Technical Service Bulletin

MODEL(S) AFFECTED:	T1 Battery Scrubber equipped with AGM Battery (Model No.: 9008635, 9008636) Only models manufactured before serial number 10550969 (December 2011)
SUBJECT:	Battery damage due to over-discharge. If machine is not used and left off charger for extended periods, beyond one month, the internal battery discharge indicator (BDI) will continue to draw power from battery resulting in possible battery damage. If battery voltage drops into the over-discharged range, the battery charger will not operate therefore prevent battery to take a charge.
PURPOSE:	To protect battery from over-discharging, order the upgraded BDI jumper harness (p/n 1069703). The upgraded jumper harness is equipped with BDI charge relay as shown below.
NOTES:	This upgrade is intended on machines if replacing a damaged AGM battery or when servicing machine on a non-related issue. For questions, contact the Tennant Customer Service Department. Warranty Information: Standard warranty terms apply.

Upgraded BDI Jumper Harness (p/n 1069703)

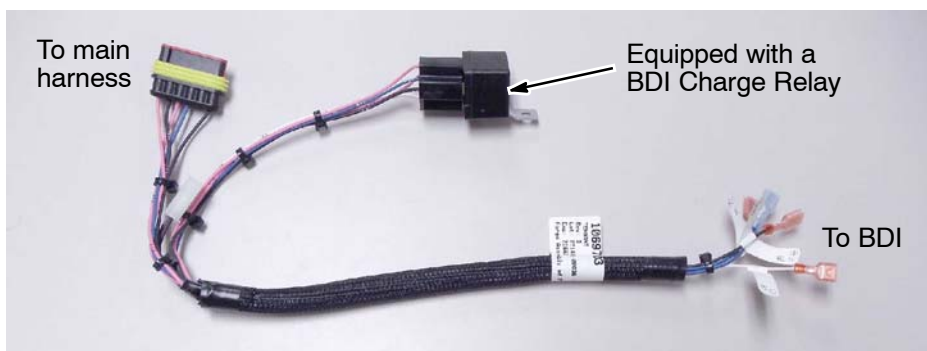
Discontinued BDI Jumper Harness (p/n 1064899)

Installed on models manufactured before serial number 10550970.
Now obsolete replaced by 1069703.

Installed on models manufactured after serial number 10550969.

NOTE: If storing a machine that is not equipped with the BDI relay for extended periods, it's suggested to disconnect the battery cable connections.
